<b>PCN Number:</b>	20241119002.2	<b>PCN Date:</b>	November 20, 2024																		
<b>Title:</b>	Qualification of RFAB using qualified Process Technology, Die Revision, Assembly/Test site (MLA) & alternate BOM qualification for select devices																				
<b>Customer Contact:</b>	Change Management Team	<b>Dept:</b>	Quality Services																		
<b>Proposed 1<sup>st</sup> Ship Date:</b>	May 19, 2025	<b>Sample requests accepted until:</b>	December 20, 2024*																		
<b>*Sample requests received after December 20, 2024 will not be supported.</b>																					
<b>Change Type:</b>																					
<input checked="" type="checkbox"/> Assembly Site	<input checked="" type="checkbox"/> Design	<input type="checkbox"/> Wafer Bump Material																			
<input checked="" type="checkbox"/> Assembly Process	<input type="checkbox"/> Data Sheet	<input type="checkbox"/> Wafer Bump Process																			
<input checked="" type="checkbox"/> Assembly Materials	<input type="checkbox"/> Part number change	<input checked="" type="checkbox"/> Wafer Fab Site																			
<input type="checkbox"/> Mechanical Specification	<input checked="" type="checkbox"/> T

##### Die Rev:

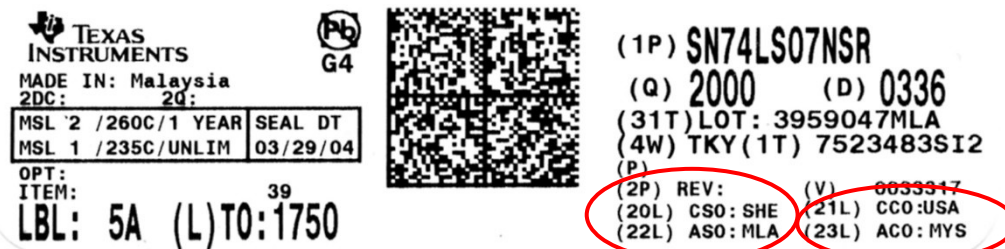
Current Fab Site			Additional Fab Site			Fab Site	Process	Wafer Diameter	Fab Site	Process	Wafer Diameter	SFAB	JI1	150 mm	RFAB	TIB	300 mm	
Current Fab Site			Additional Fab Site																		
Fab Site	Process	Wafer Diameter	Fab Site	Process	Wafer Diameter																
SFAB	JI1	150 mm	RFAB	TIB	300 mm																
The die was also changed as a result of the process change.																					
<b>Group 1 BOM Table (FAB/Process migration, die change plus BOM update):</b>																					
		Current	New																		
Bond Wire composition/diameter		Cu, 0.8 or 1.0 mil	<b>Cu, 0.8 mil</b>																		
Probe Site **		SFAB	<b>No Probe</b>																		
** LM2902BAQPWRQ1 & LM2902BQPWRQ1 are Currently on no probe flow																					
<b>Group 2 BOM Table (RFAB/Process migration, die change plus MLA as new Assembly site &amp; BOM update (FMX Devices):</b>																					
		FMX	MLA																		
Bond Wire composition/diameter		Cu, 1.0 mil	<b>Cu, 0.8 mil</b>																		
Final Test site		TI Mexico	<b>TI Malaysia</b>																		
Probe site		SFAB	<b>No Probe</b>																		
<b>Group 3 BOM Table (RFAB/Process migration, die change plus MLA as new Assembly site &amp; BOM update (TAI Devices):</b>																					
		TAI	MLA																		
Bond Wire composition/diameter		Au, 0.96 mil	<b>Cu, 0.8 mil</b>																		
Mold Compound		4209640	<b>4211880</b>																		
Mount Compound		4208458	<b>4147858</b>																		
MSL		3	<b>1</b>																		
Final Test site		TI Taiwan	<b>TI Malaysia</b>																		
Probe site		SFAB	<b>No Probe</b>																		
Test coverage, insertions, conditions will remain consistent with current testing and verified

Die Rev [2P]	Die Rev [2P]
A,-	<b>B</b>
